## **Henty Road, Burekup WA**

### **Road Improvements between 0.04 - 11.61 Sk.**

## **Road Safety Audit**

### **Stage 3 - Detailed Design**

Photo 1 – Advance warning signage installed at the approach to the intersection.

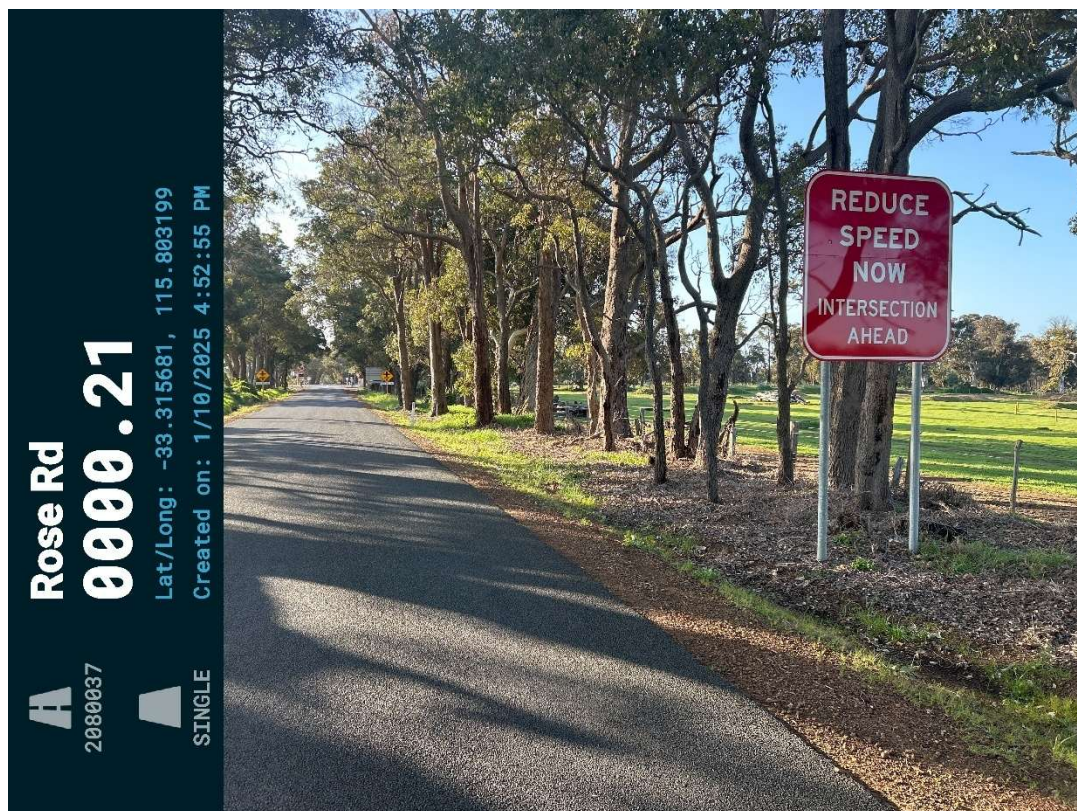
The advance signage “Reduce Speed Now – Intersection Ahead” would indicate that road users have previously approached the railway crossing and intersection too fast, resulting in signage being placed as a mitigation.

The narrow road pavement at the railway crossing should match the width of the proposed works, or width marker signage and additional guide posts should be installed to guide the road user.

**Photo 2 – Advance warning signage using Side Road signage installed at the approach to the railway crossing and intersection.**

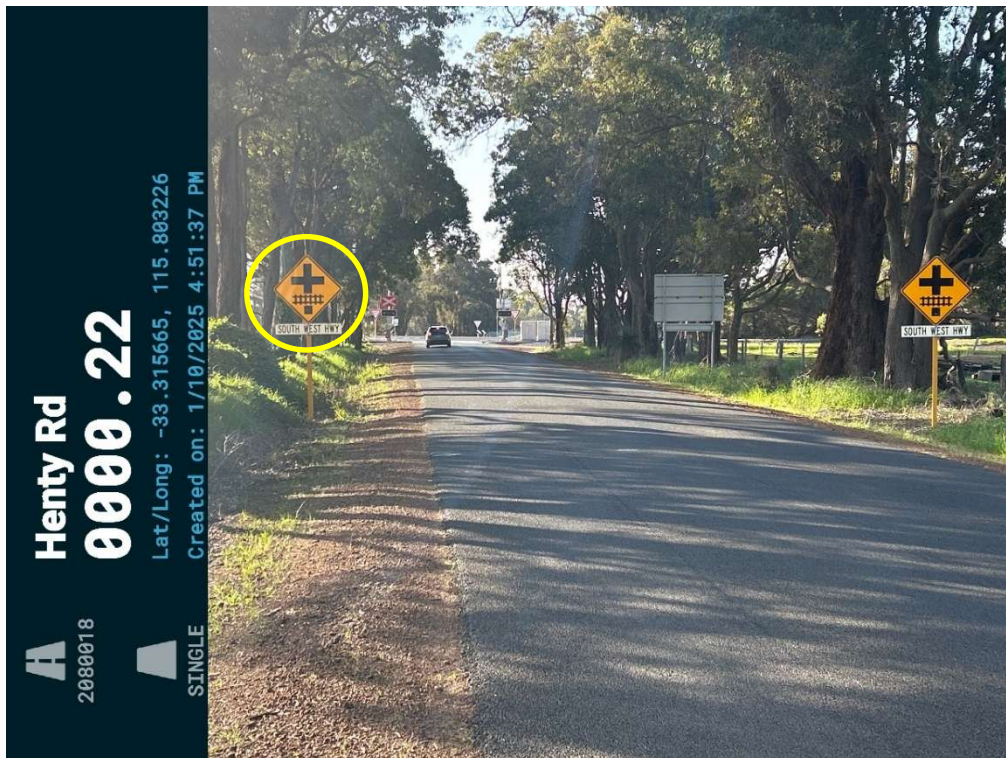
Advance warning signage has also been installed for the rail crossing. Side Road signs have been used which are not technically correct, but do provide the road user a clear guide of the crossing and crossroad ahead. Crossroad signs are not to be used on the approach to a Give way or Stop sign (AS 1742.2).

Width markers could be installed to alert road users of the narrow road pavement at the railway crossing. It was also noted at the site inspection, that the road pavement has undulations at the culvert crossing close to the railway crossing. This could result in loads on vehicles moving, making the vehicle unstable.

Main Roads WA should be requested to install an appropriate speed zone on the approach to the railway crossing.

Figure 7 - Part of the design drawing.

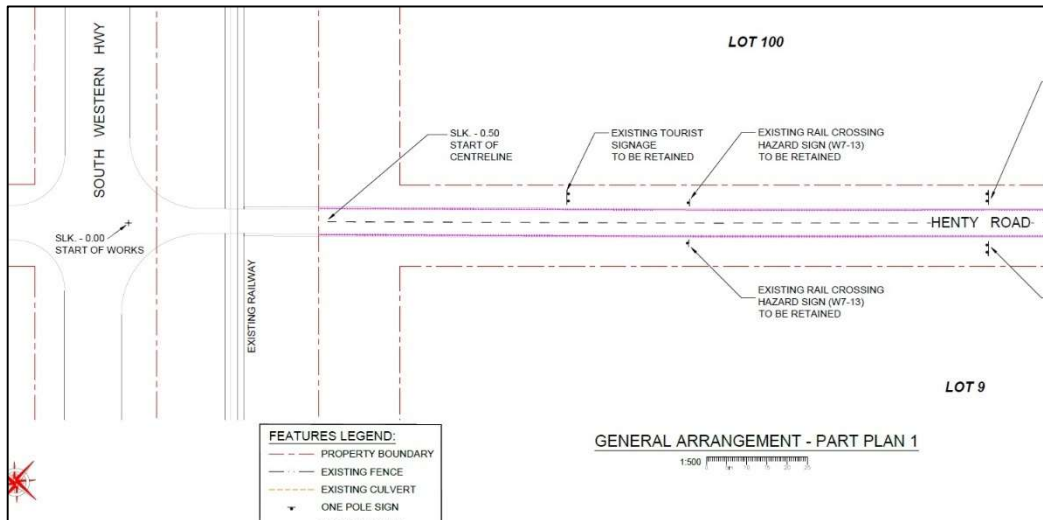
The centre line marking on the approach to the railway crossing is shown as a broken line. The AS 1742.7 suggests that the centre line should be solid on approach from the first warning sign, approximately 0.29 SLK.

The design drawings do not show the horizontal alignment of the road, so determining where barrier line marking should start and stop is challenging. Prior to the centre line marking being installed, the start and stop points of barrier line marking should be confirmed.

The painted centre line should be installed to Main Roads WA requirements.

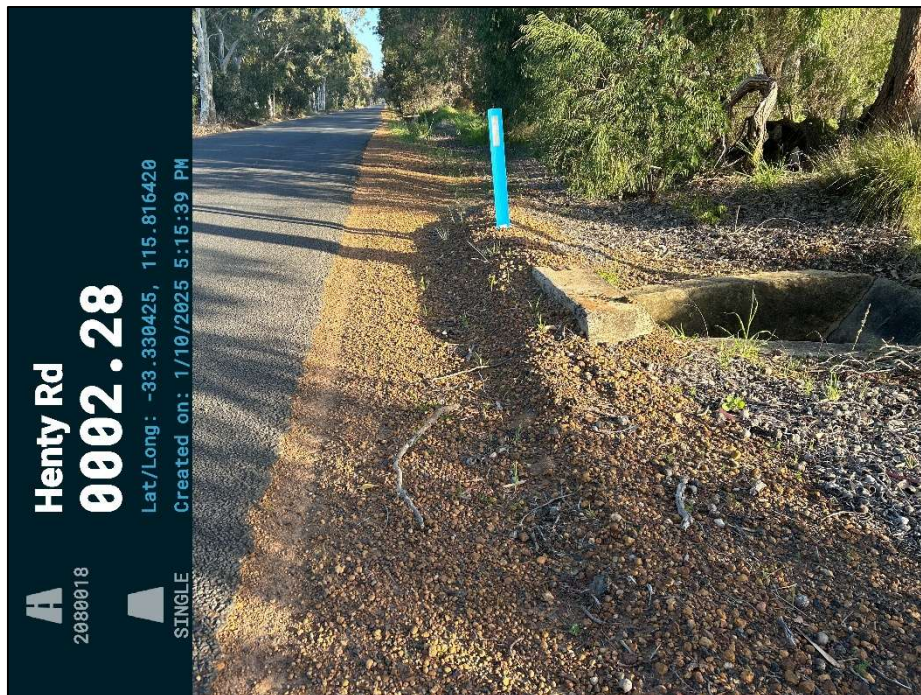
**Finding 2.2 – The large tree stump is close to the traffic lane and should be removed.**

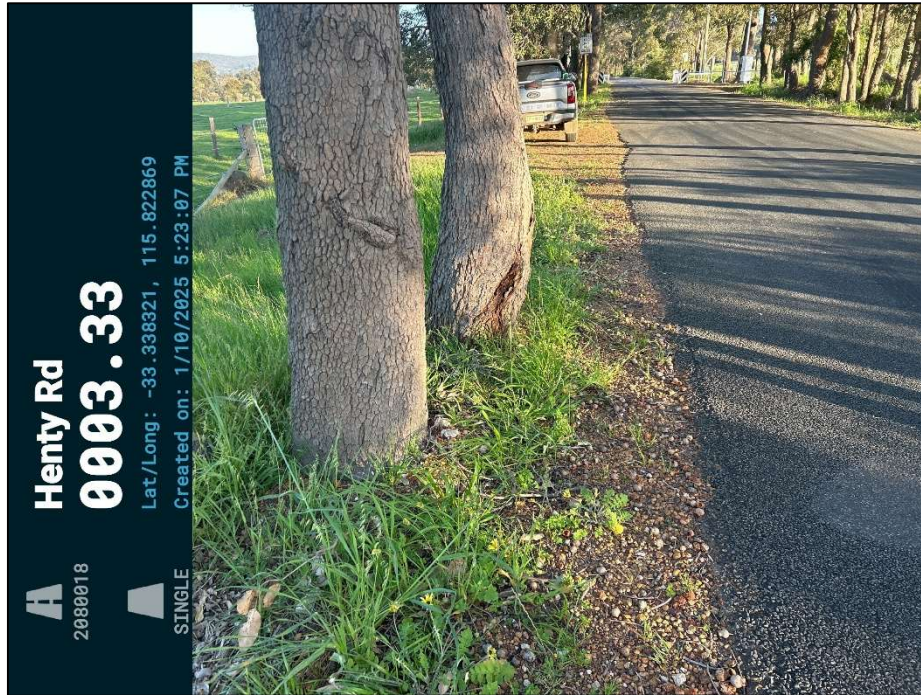
**Finding 2.2 – The culvert headwall will be close to the traffic lane and should be delineated if not relocated.**

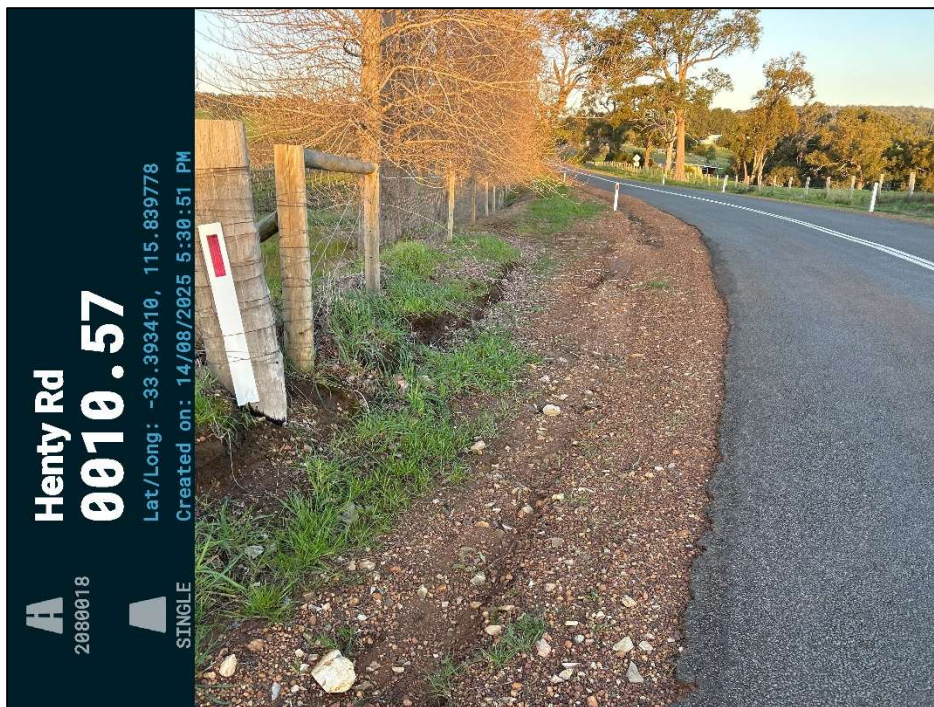
Finding 2.2 – The large trees are close to the traffic lane and should be removed.

Finding 2.2 – The large tree stump is close to the traffic lane and should be removed.

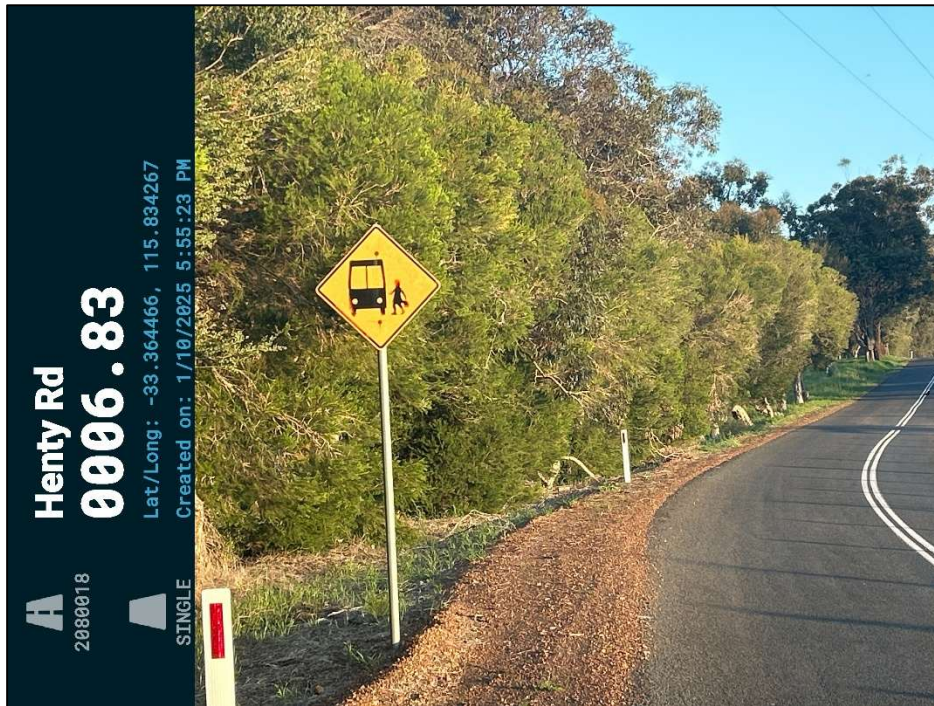
**Finding 2.2 – The existing W Beam road safety barrier is not compliant to current standards (particularly the end treatments), however with new delineation provides a suitable treatment. If the barrier was damaged, then a new barrier to the current standard should be installed.**

**Finding 2.3 – Guide posts should be installed at a consistent distance from the edge of the road and be straight.**

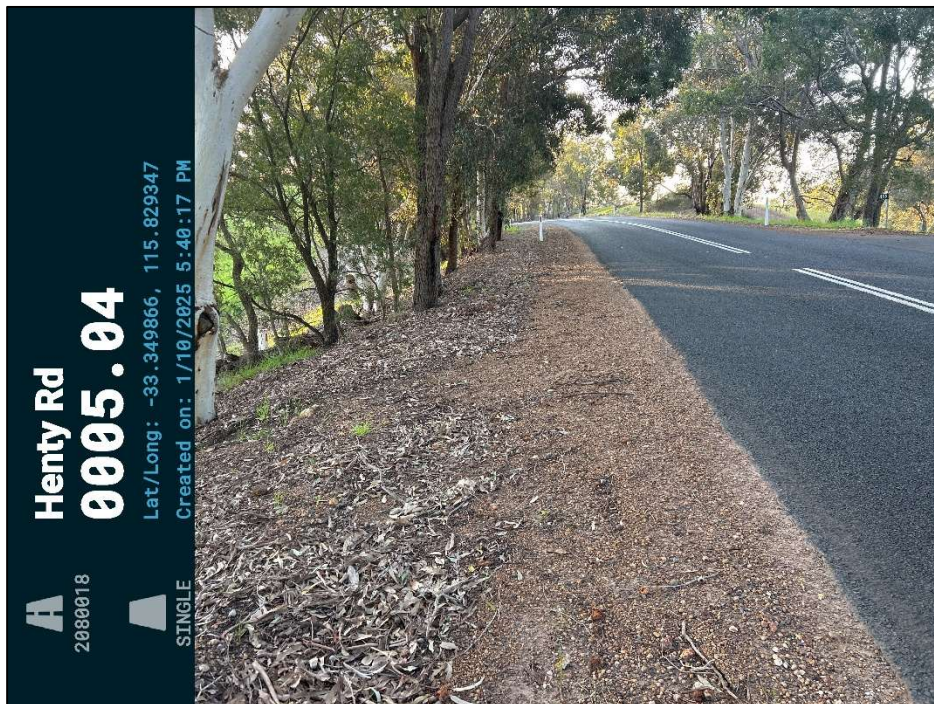
**Finding 2.3 – The Bus Stop sign is old and may not be warranted. This sign is not detailed on the design drawings.**

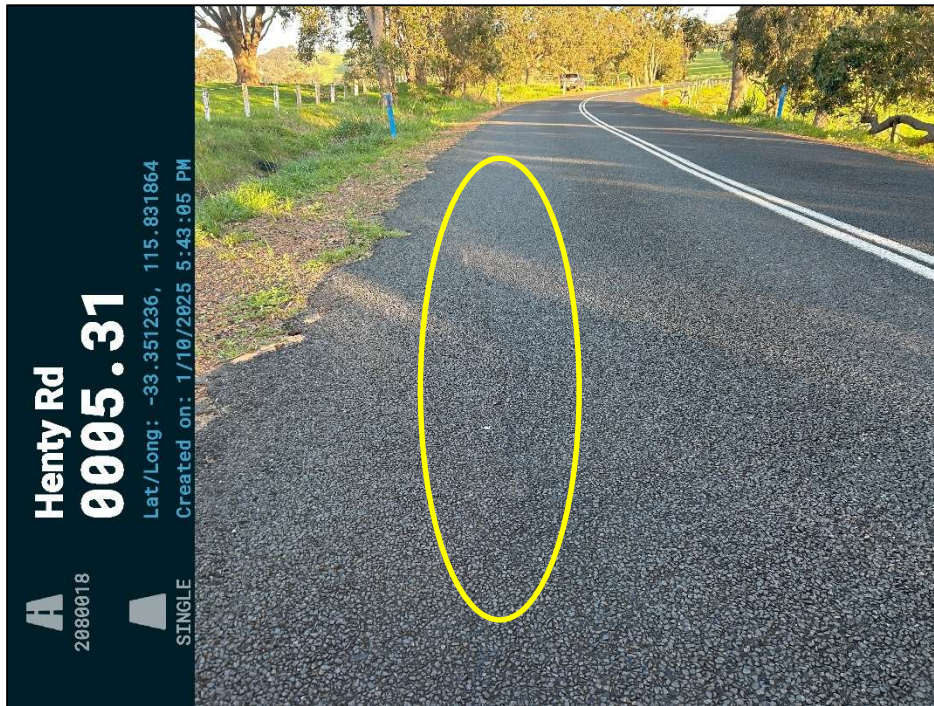
**Finding 2.3 – Where the verge is steep, or objects are close to the traffic lane, additional guide posts should be installed at closer spacing to assist guiding the road user past the hazard.**

**Finding 2.4 – The railway crossing is narrower than the sealed road pavement. Drivers may not realise the narrow section and drive over the rails.**

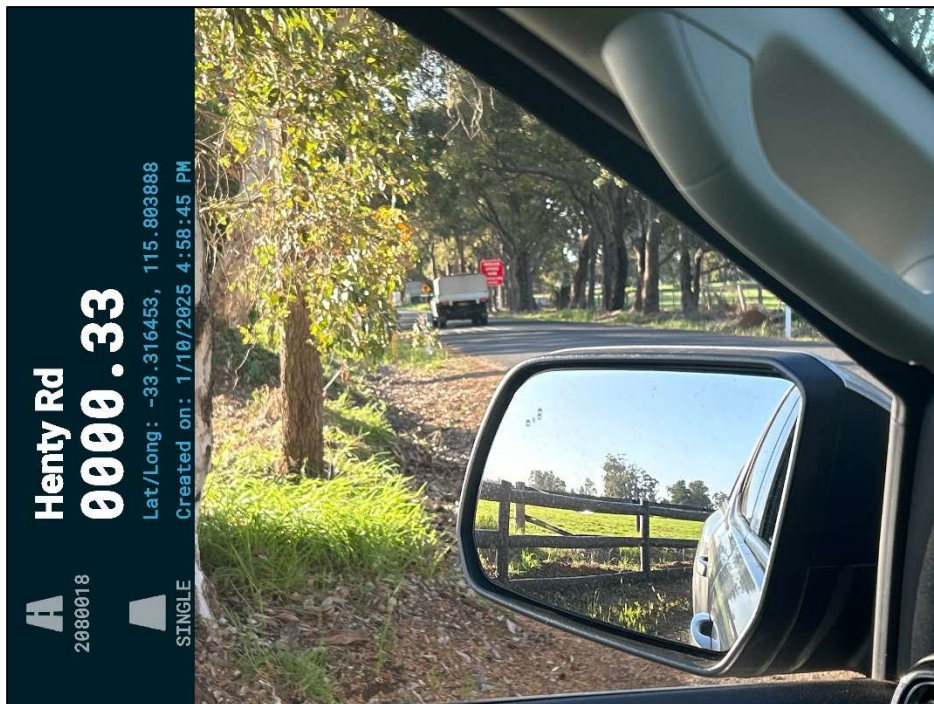
**Finding 2.4 – The railway crossing has a dip where the culvert is located, this should be made smooth.**

**Finding 2.5 – The sealed pavement undulates resulting in stormwater running down the road rather than off the road towards the shoulder. This can result in excessive water on the sealed pavement and vehicles aquaplaning on the sealed surface.**

**Finding 2.5 – The table drain is blocked, causing the water to flow over the road.**

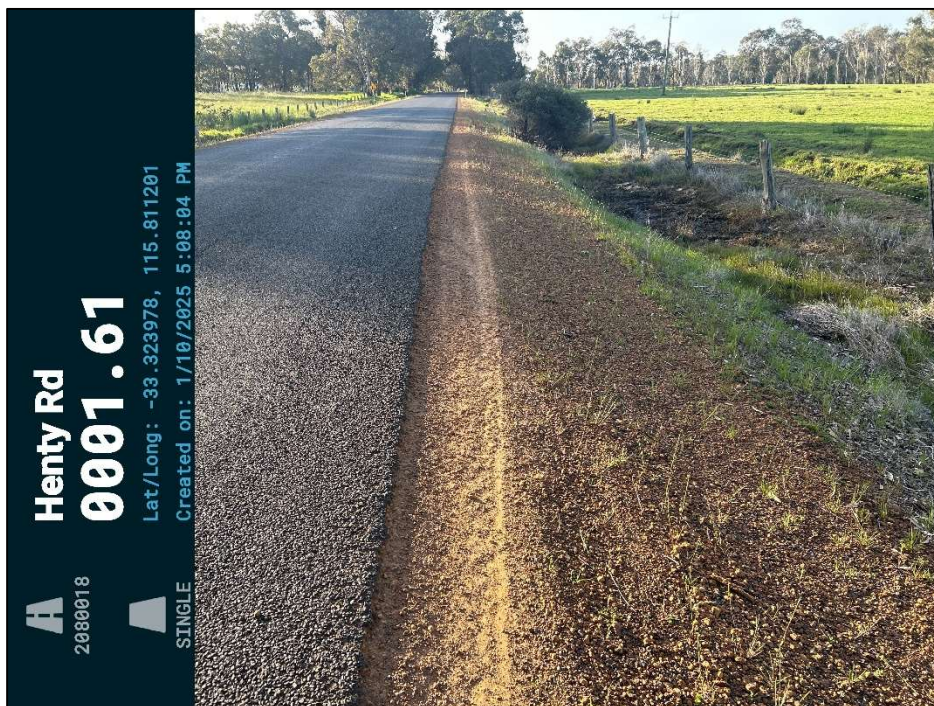
**Finding 2.6 – On approach to the rail crossing, a solid painted centre line should be installed from the first warning sign of the rail crossing. The design drawings show a dashed centre line to be installed, this should be corrected to Main Roads requirements.**

**Finding 2.7 – The access at this location has a restricted sight distance due to the vegetation. The vegetation should be trimmed to provide suitable sight distance.**

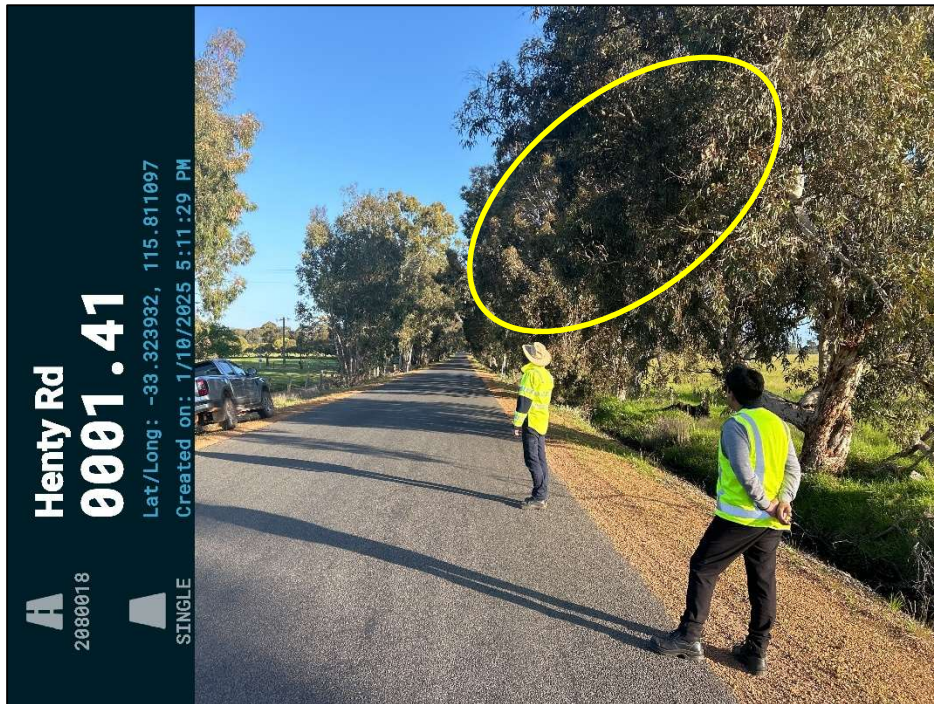
**Finding 2.7 – The access at this location has a restricted sight distance due to the vegetation. The vegetation should be trimmed to provide suitable sight distance.**

**Finding 2.8 – High vehicles are veering away from overhanging branches resulting in them travelling on the existing gravel shoulder. The design will provide additional sealed pavement, but the removal of the overhanging branches would allow drivers to remain lane correct.**
